SUBJECT: SURRY UNITS 1 AND 2 - ISSUANCE OF AMENDMENTS RE: ASME CODE
REQUIREMENTS FOR MAIN STEAM AND FEEDWATER SYSTEMS (TAC NOS.
M97908 AND M97909)

AMENDMENT NO. 212 TO FACILITY OPERATING LICENSE NO. DPR-32 - SURRY UNIT 1
AMENDMENT NO. 212 TO FACILITY OPERATING LICENSE NO. DPR-37 - SURRY UNIT 2

ATTACHMENT TO LICENSE AMENDMENT
AMENDMENT NO. 212 TO FACILITY OPERATING LICENSE NO. DPR-32
AMENDMENT NO. 212 TO FACILITY OPERATING LICENSE NO. DPR-37
DOCKET NOS. 50-280 AND 50-281

SAFETY EVALUATION BY THE OFFICE OF NUCLEAR REACTOR REGULATION

MAIN STEAM AND FEEDWATER LINES - UNIT 2
SURRY POWER STATION
UNITS 1 AND 2

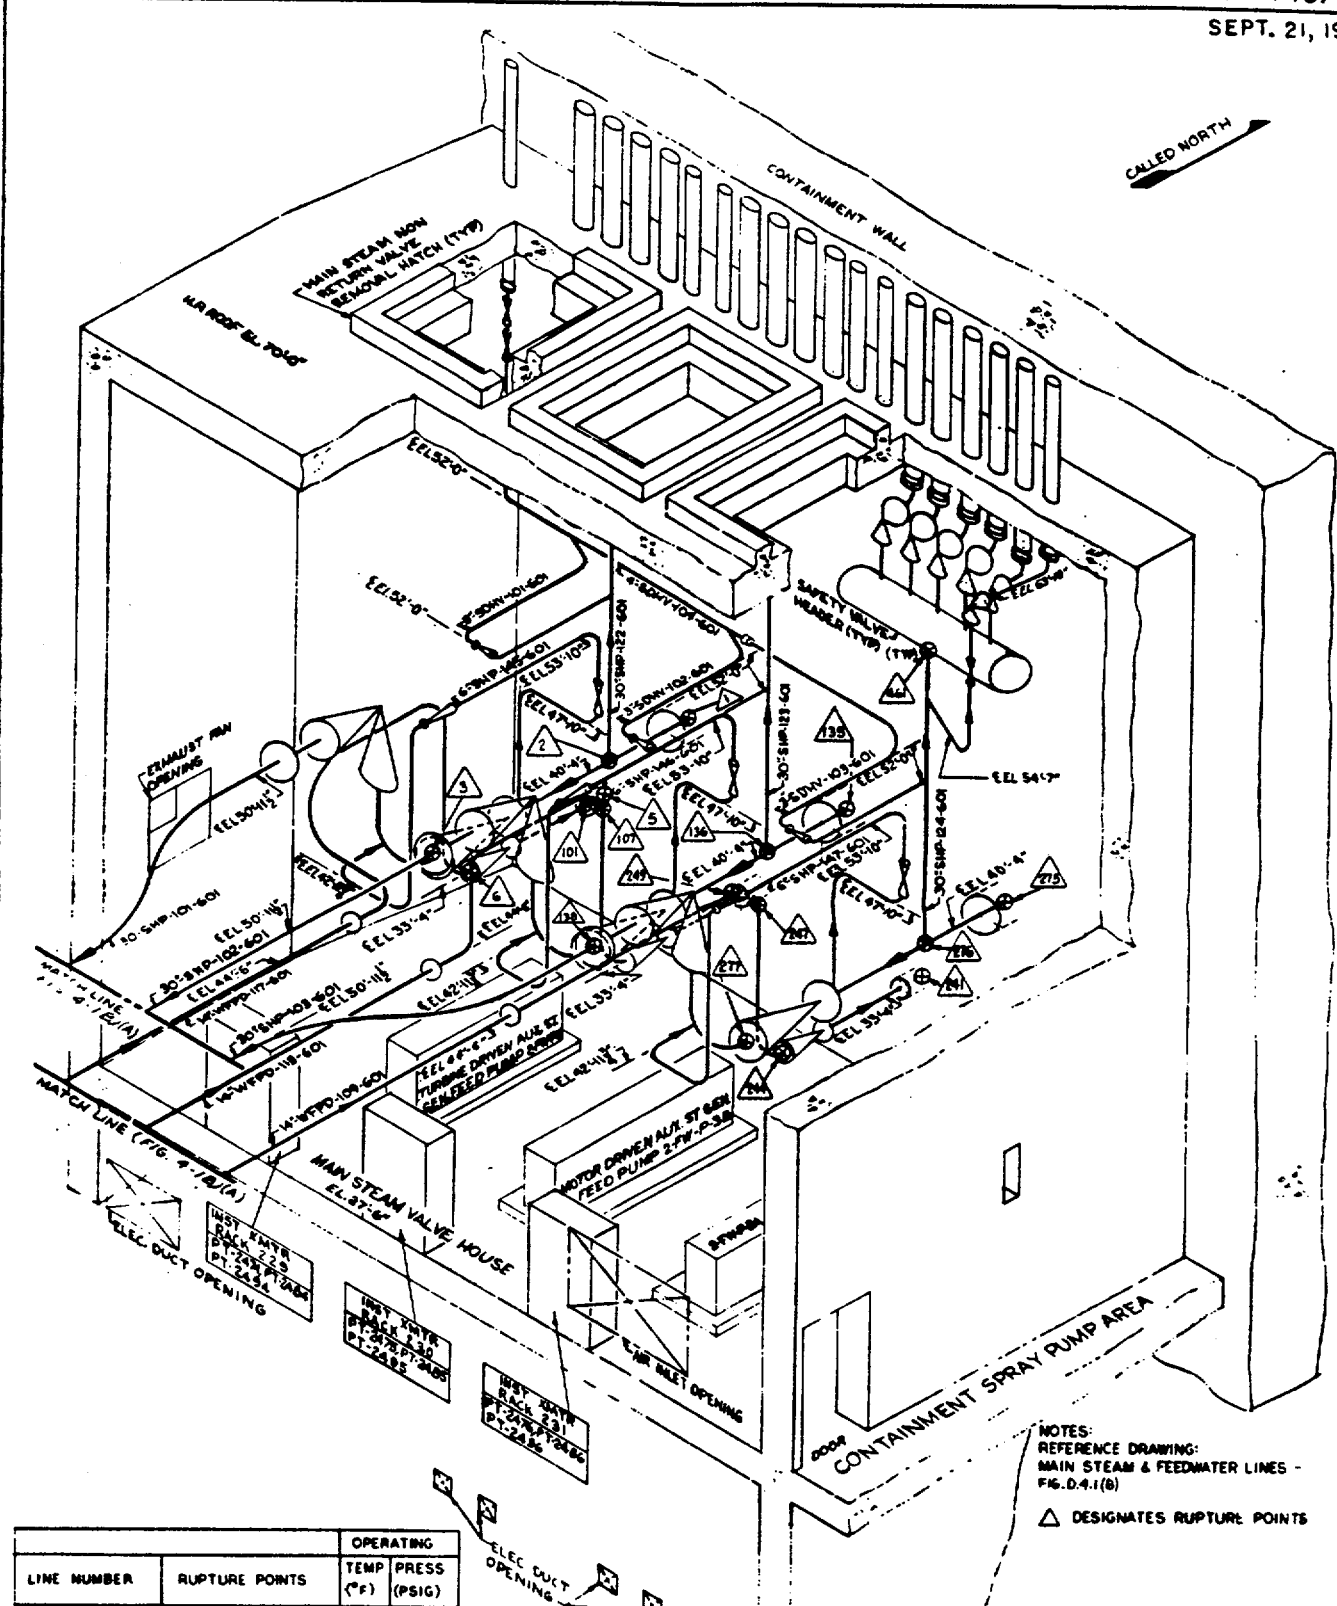
Additionally, subsequent to the February 3, 1997 submittal, it was identified that pages TS 4.15-1, TS 4.15-3, and TS Fig. 4.15 were inadvertently omitted in previous amendments (Amendments 39 and 40) to the Surry, Unit 1 and Unit 2 TS. Therefore, for the purpose of clarity, in addition to the specific proposed change noted above, TS 4.15 has been revised to include those pages which were inadvertently omitted.

- A. For the 20 welds identified in TS Figure 4.15:
1. At the first refueling outage period a volumetric examination shall be performed with 100 percent inspection of welds in accordance with the requirement of ASME Section XI Code, Inservice Inspection of Nuclear Power Plant Components, to

- B. For all welds other than those identified in TS Figure 4.15:
1. Welds in the main steam lines including the safety valve headers and in the feedwater lines in the main steam valve house shall be examined in accordance with the requirements of subsection IWC of the ASME Section XI Code.
